# HISTORIC AND DESIGN REVIEW COMMISSION

December 04, 2019

**HDRC CASE NO:** 2019-668  
**ADDRESS:** 328 E HUISACHE AVE  
**LEGAL DESCRIPTION:** NCB 3088 BLK 4 LOT 7 & E 25 FT OF 6  
**ZONING:** MF-33,H  
**CITY COUNCIL DIST.:** 1  
**DISTRICT:** Monte Vista Historic District  
**APPLICANT:** Sue Ann Pemberton/Mainstreet Architects Inc.  
**OWNER:** Amy Scheinman/SCHEINMAN AMY L  
**TYPE OF WORK:** Exterior modifications, porch modifications  
**APPLICATION RECEIVED:** November 01, 2019  
**60-DAY REVIEW:** December 31, 2019  
**CASE MANAGER:** Stephanie Phillips  
**REQUEST:**

1. Construct a new front porch.
2. Modify the existing front fenestration pattern.
3. Construct a new screened rear porch.

EXISTING  
NORTH ELEVATION

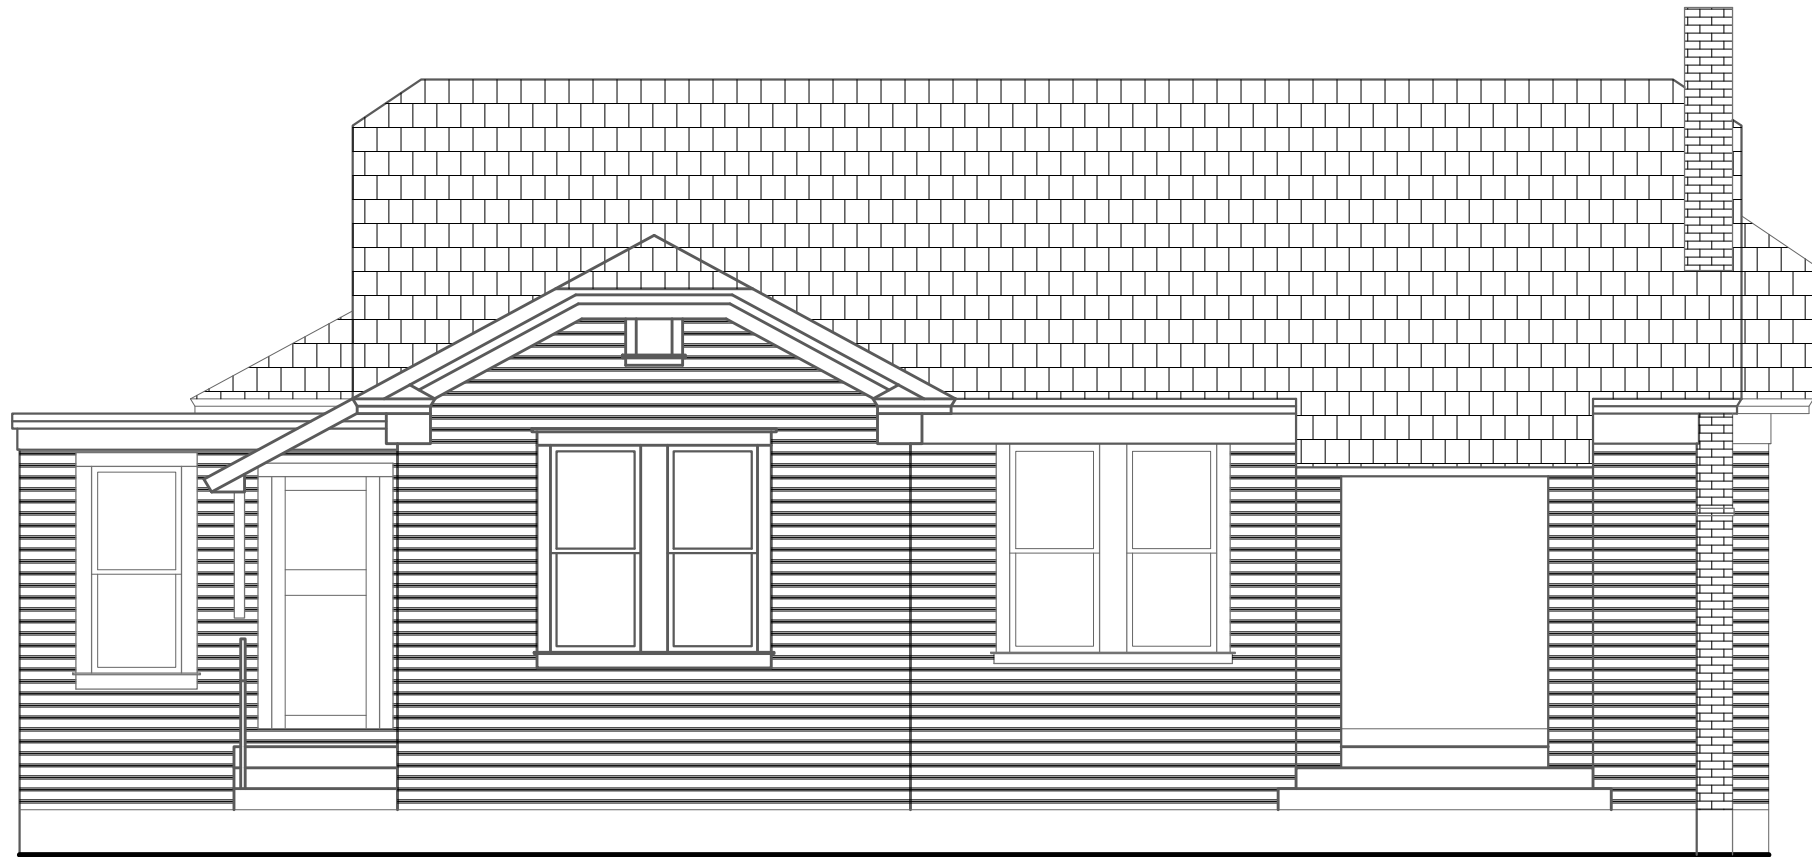
- c. FENESTRATION MODIFICATIONS – Per the submitted proposed elevation, the applicant has proposed to modify the front fenestration pattern. Two existing ganged windows will be relocated and swap locations with an existing non-original front addition. A new front door with side lites will be installed in the location of the existing ganged windows. As noted in finding b, the original front door of the structure is located on the west side of the front gable. The submitted existing and proposed elevation drawings do not indicate the intent for the original front door. The Guidelines state that existing fenestration configurations should be retained. Staff does not find the proposal consistent.

Item 2, Staff does not recommend approval of the fenestration modifications based on finding c. Staff recommends that the existing fenestration pattern, including the side front door, be retained and restored.

101 FLOOR PLAN  
SCALE: 1/4" = 1'-0"

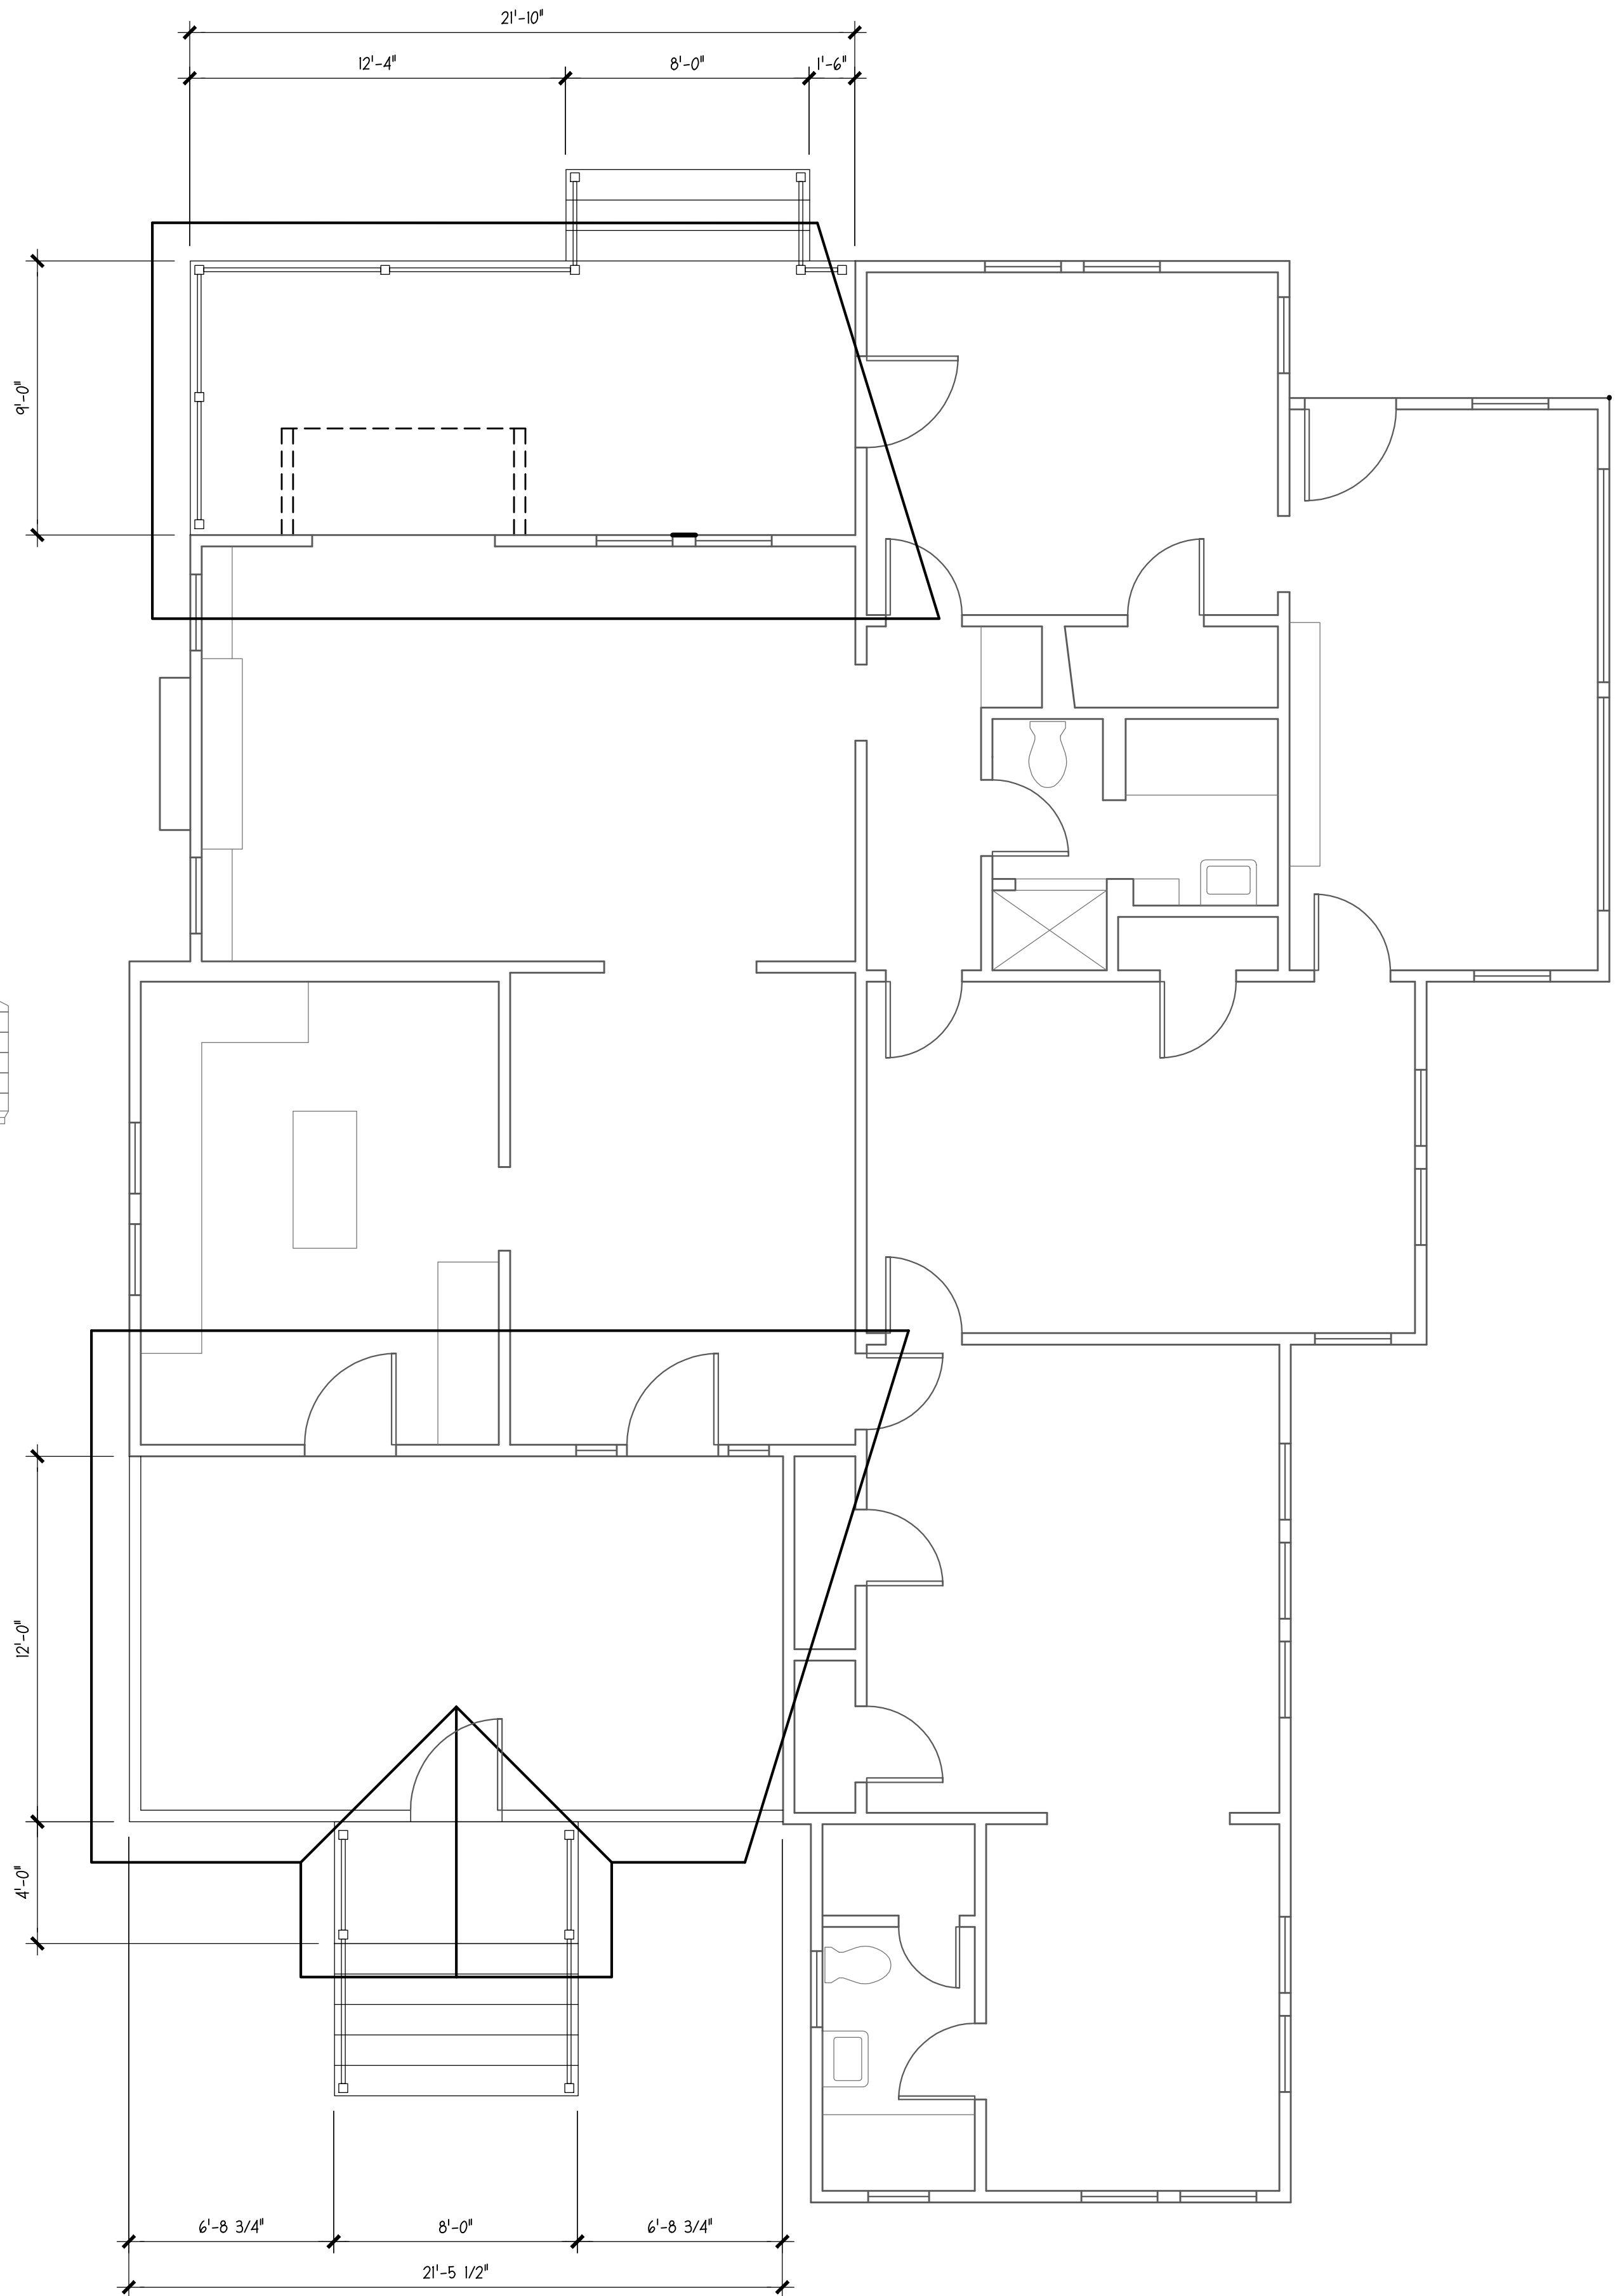
- b. FRONT PORCH – The applicant has proposed to construct a new front porch to the existing historic structure. The applicant has proposed a porch that will span the width of the inset portion of the front façade adjacent to the front gable. The porch will feature a low-sloping shed roof with simple wooden posts and railings and stairs that lead to the public right-of-way. The original entrance configuration, based on Sanborn Maps and remaining evidence, features a side-access front door located on the west side of the front gable. Based on the same evidence, the structure did not originally feature a front porch. According to the Historic Design Guidelines, porches and related entry elements should be restored to their original configuration. New elements should not detract from the original design of the structure or convey a false historic appearance. Staff does not find the proposed porch consistent with the Guidelines. Staff finds that the original entryway configuration should be retained and restored. Staff finds that a simple porch element emphasizing the existing original front entryway may be appropriate.

Item 1, Staff does not recommend approval of the construction of a new front porch based on finding b. Staff recommends that the applicant explore designs for a simple porch element emphasizing the existing original front entryway.
